XK8

## TECHNICAL BULLETIN

Removing Redundant EGR Pipe –  
Authorized Modification –  
Service Action S831

MODEL 1997 MY  
XK8 Range  
VIN 001036-011461

ILLUSTRATION 1

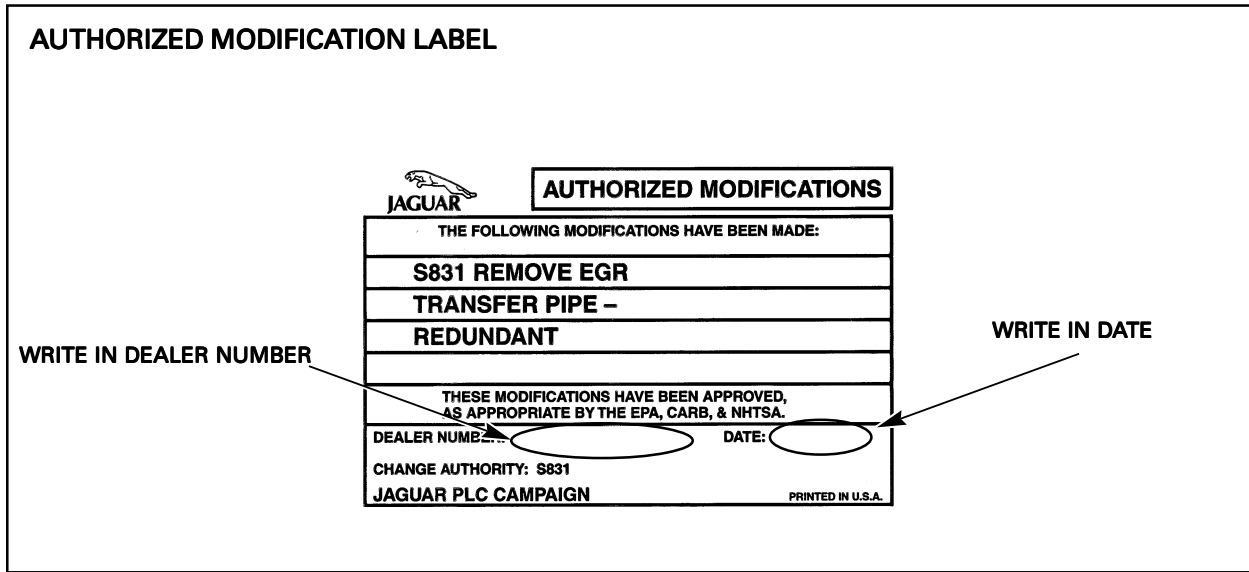
1. Check the B-pillar for an S831 label (Illustration 1). If no S831 label is present, open the hood and cover the fenders.
2. For access remove the air intake duct/mass air flow sensor/air cleaner cover assembly.
3. Remove the bolts that secure the E.G.R. transfer pipe to the E.G.R. valve.
4. Remove the nuts that secure the E.G.R. transfer pipe to the exhaust manifold.
5. Remove and discard the E.G.R. transfer pipe.
6. Remove all residues from the E.G.R. valve and exhaust manifold.
7. Install a blanking plate and gasket on both the E.G.R. valve and the exhaust manifold, from where the pipe has been removed. Use the original nuts and bolts that previously retained the pipe.  
Torque wrench setting - nuts & bolts: 18 - 24 Nm.
8. Reinstall the air intake duct/mass air flow sensor/air cleaner cover assembly.
9. Remove the fender covers and close the hood.

**Write the date and your dealer number on the S831 authorized modification label (Illustration 1).** Apply the label to the B-pillar on XK 8 vehicles. (This label will immediately indicate to any other dealer that the vehicle concerned has already been rectified). Do not cover or remove any stickers referring to Reflash modifications.

ILLUSTRATION 2

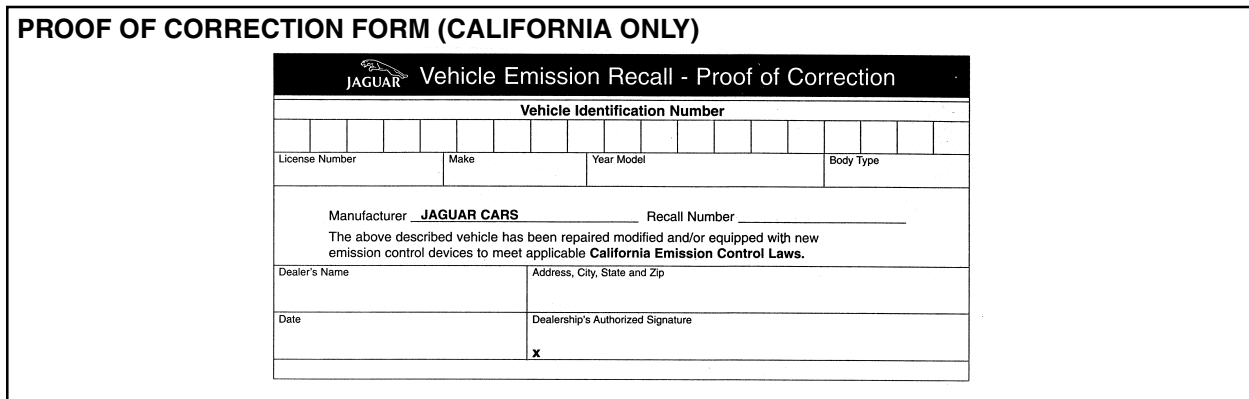
**California Dealers:** Fill out and place the salmon colored “Vehicle Emission Recall - Proof of Correction” form (Illustration 2, part no. S CAL/RCL) in the vehicle glove compartment.
